## Service Bulletin

### R1710

Aftertreatment - 43

Model Year 2017 Retrofit – Urea Quality Sensor

### **P/N Q21-6127-002 UQS**

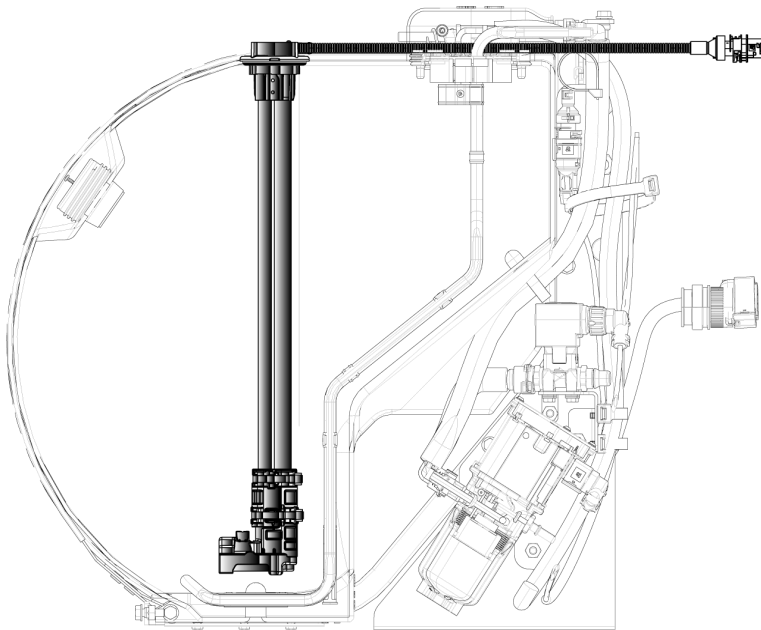
Install the new sensor and reinstall the DEF fluid tank in reverse order of removal. Refer to the appropriate image below based on DEF tank part number.
